## Design Advice Request

### SUMMARY MEMO

**Re:** EA 21-007324 DA – Earthquake Ready Burnside Bridge – Bridge Type Selection (HLC)  
EA 21-007685 DA – Earthquake Ready Burnside Bridge – Bridge Type Selection (DC)  
Joint Design Advice Request Commission Summary Memo – March 4, 2021

## Tied Arch: Bascule Variations

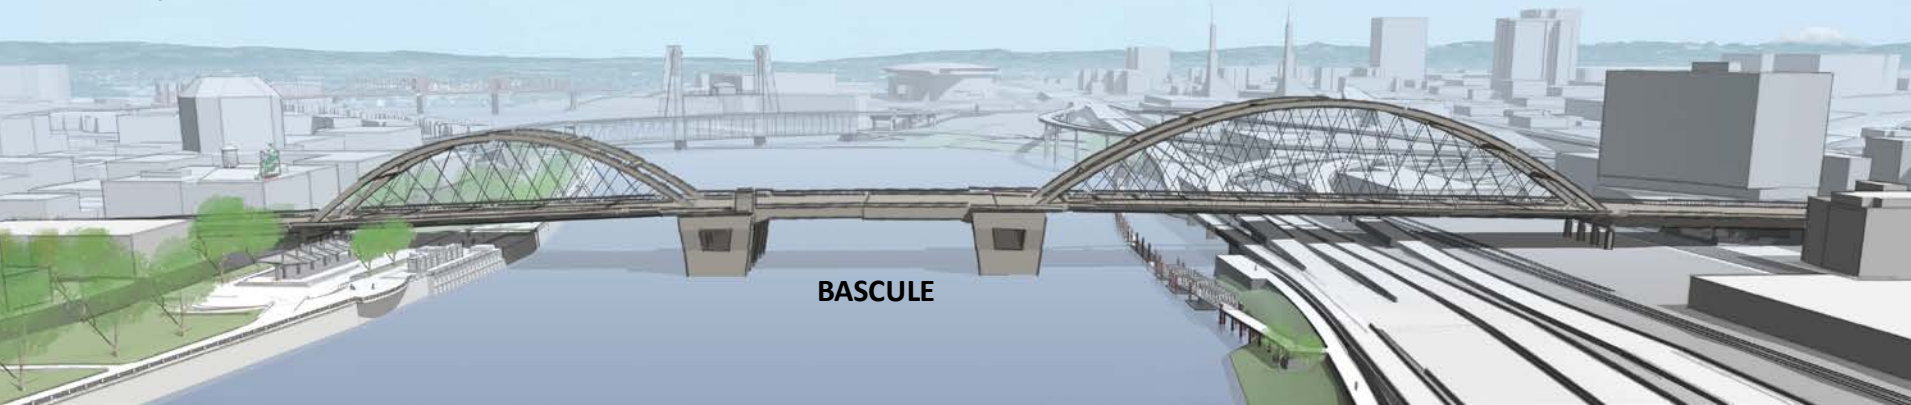
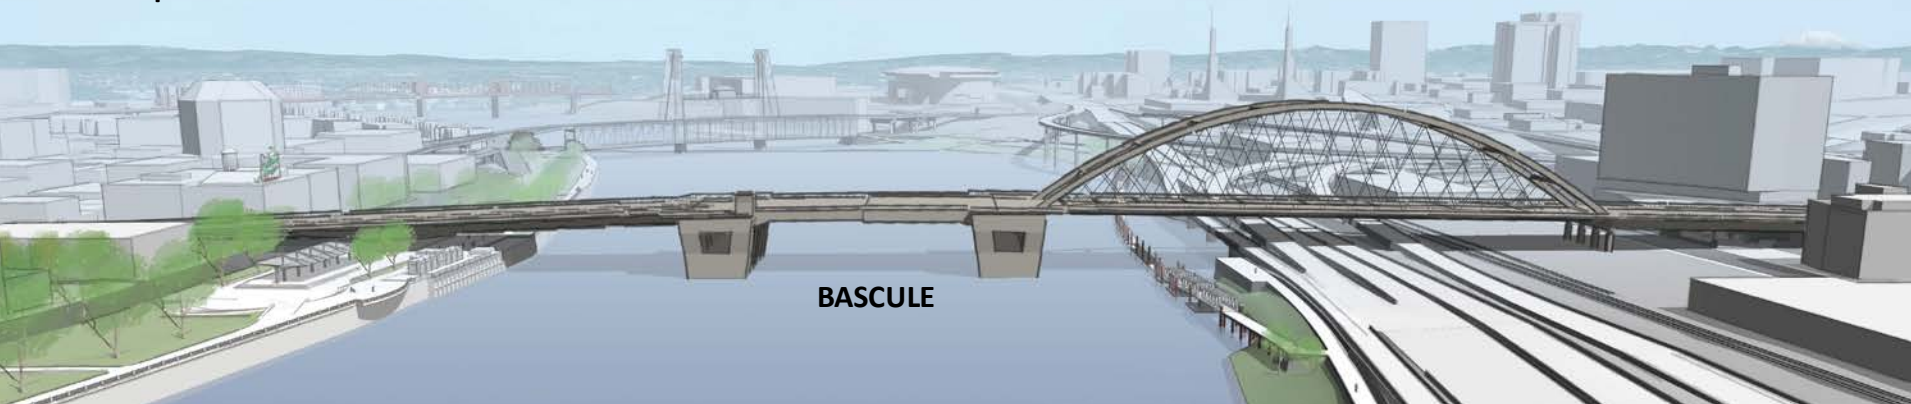
- One Commissioner noted that the girder-bascule-tied-arch option looks like three bridges bandaged together and is a less cohesive image than the girder-bascule-cable-stayed option which, while needing refinement, somehow lends itself more to the story of asymmetry. He noted that we can emphasize the moment on the east side, with shorter steeper cables on the east and longer cables on the west for added drama.

## Cable Supported: Bascule Variations

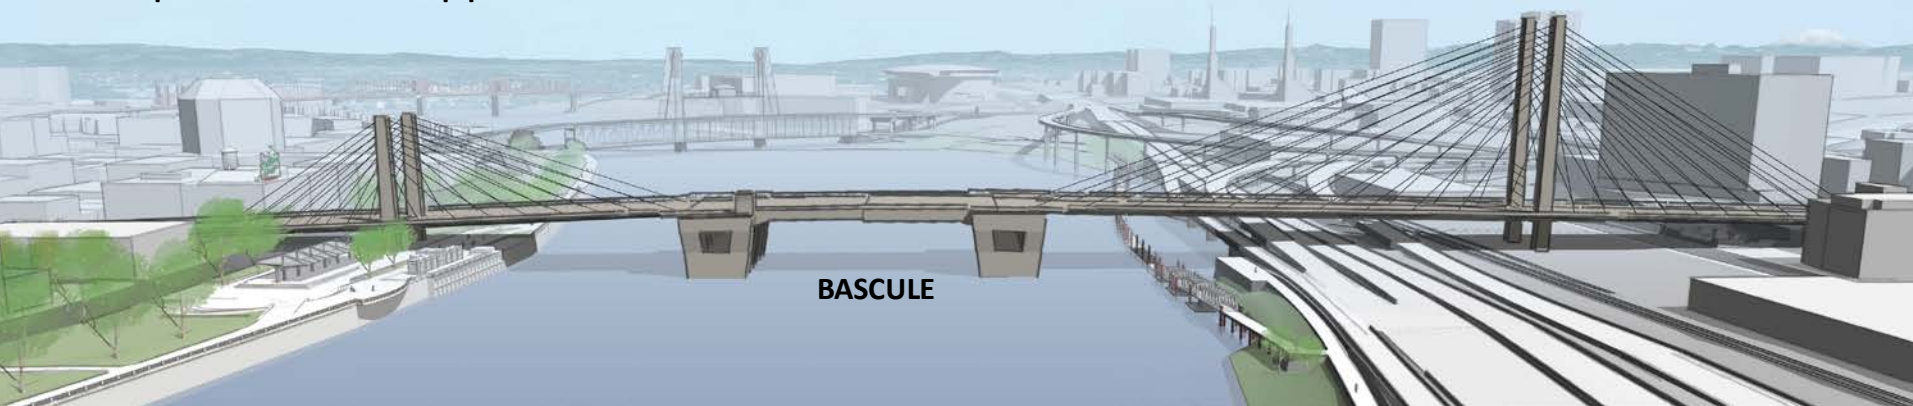
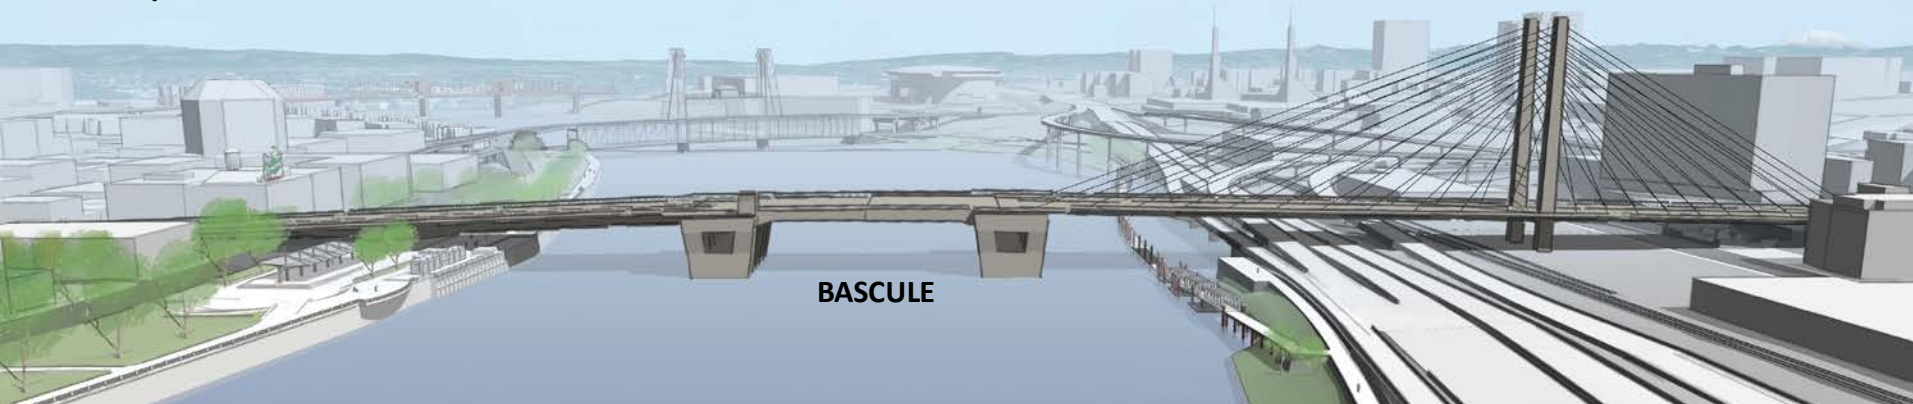
**Executive Summary.** Consensus was achieved across both Commissions that the preferred bridge types are as follows: West approach – Girder; Central span – Bascule; East approach – Cable-stayed. The Commissions believed that adequate clearance could be achieved at the west end with the girder option while preserving views and the existing relationship between the bridge and the historic district. The bascule bridge at the center also allows for open views from the center of the river. The cable-stayed bridge at the east responds to the dynamic nature of this developing part of the City. The Commissions noted that the differing contexts on the west and east, as well as the technical requirements due to the differing geology and existing built environments on the west and east precipitates the need for asymmetrical engineering which allows the opportunity for an asymmetrical design response. They stated that a girder-bascule-cable-stayed design accommodates this asymmetry in a more cohesive and elegant way than the other options.

- Many of the comments noted under “Context” translate directly to the Commissions’ comments on “Bridge Aesthetic”.
- The Commissions noted that because the built contexts on either side of the river are so disparate and because the geotechnical requirements are also so different, the form of the bridge can respond to these variations by having dissimilar forms. They noted that these asymmetrical conditions require an asymmetrical response. Specifically, they unanimously voiced support for a girder on the west, bascule in the middle, and cable-stayed on the east.

- One Commissioner noted the cable-stayed bridge lends itself to this idea of asymmetry; he noted he would like to see longer more graceful cables extending to the bascule piers on the west side of the towers with shorter steeper cables on the east side. He also noted that a tied arch lacks the grace of a through arch bridge like the Alsea Bay Bridge.

- One Commissioner noted the idea of towers on the east side for a cable-stayed bridge with a bascule in the center was almost reminiscent of a drawbridge. He noted that the prow shape of the existing piers is romantic and responsive to context of the flow of the river. He stated that not having too many vertical elements helps it feel less cluttered which is appropriate for the bridge’s location as the cardinal center of the city.

## Waterfront Park Vertical Clearances

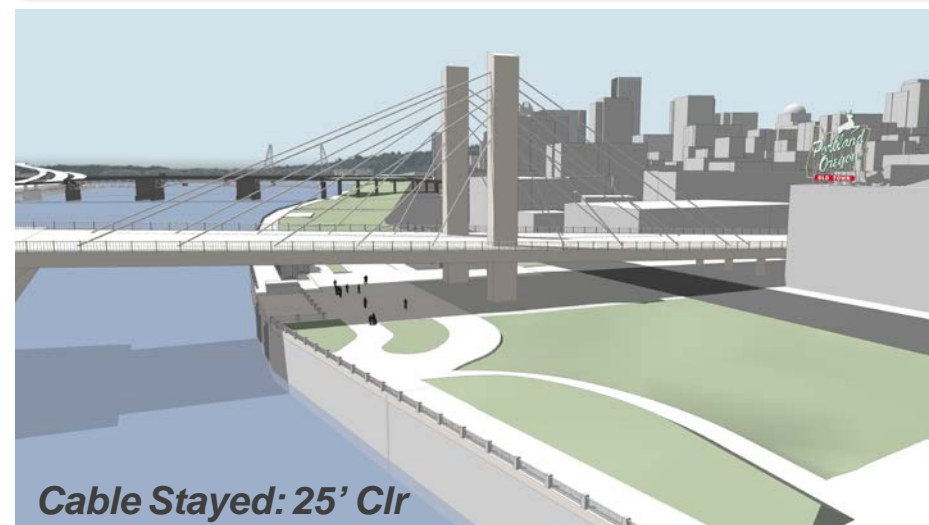
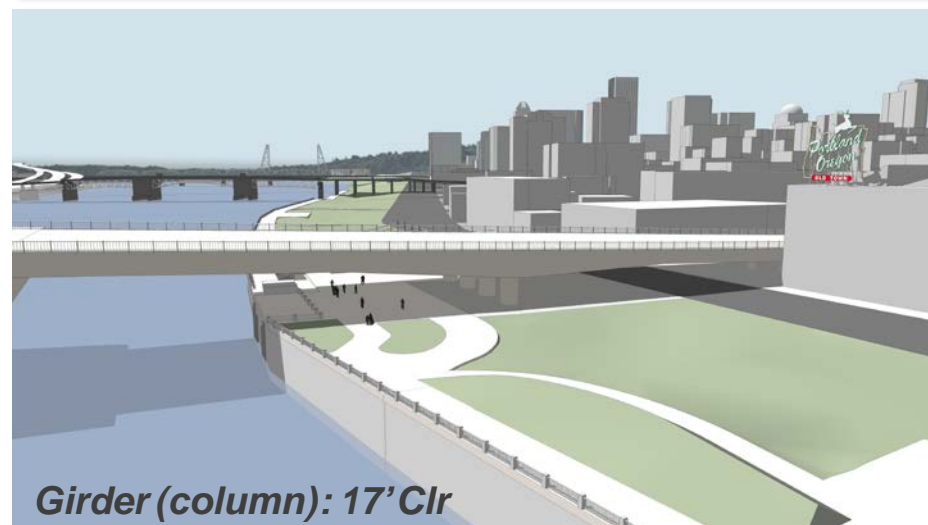
- Several Commissioners noted that when one arrives in Old Town, you should be able to see into Old Town without the bridge structure blocking views, and the clearance below should be maximized to the greatest extent possible.

- Commissioners noted that there are tradeoffs with the girder, as originally presented. One Commissioner noted that there is so much repair work that needs to happen under the bridge that reduced clearances may not help; however, she also noted that because of the amount of repair that needs to occur under the bridge, the additional two feet of clearance that are gained with the tied-arch and cable-stayed options are not enough to compensate for the losses that those above-deck structures would have on the west side on-bridge experience.. (The Commissioners were later shown a drawing with the slimmed-down girder option on the west and four sets of columns between the MAX line and the river that would allow clearances comparable to those with the tied arch and cable-stayed options.) Commissioners believed that a few more columns to accommodate a slimmer girder was acceptable in order to preserve the experience on the top of the bridge.

- **West side.** On the west side of the river, the bridge crosses over Waterfront Park. The current clearance under the existing bridge is 23' clear. Of the proposed bridge types, the cable-supported and tied arch options show a clearance of 25' clear while the girder option only allows 17' clear. Portland Parks & Recreation has indicated a desired for maximum clearance and has also expressed a desire for minimizing or eliminating columns in the park, as this will allow maximum opportunities for visibility, safety, and programming of this space. Regardless of which option is selected, the number of columns between the seawall and SW 1<sup>st</sup> Avenue will be significantly reduced from the current condition. Please note that location of the primary structural columns determines where over-deck structures will be located and therefore how those elements will interface with existing buildings on either side of the river. Consider images on pages 12, 15, 18, 19, and 22.
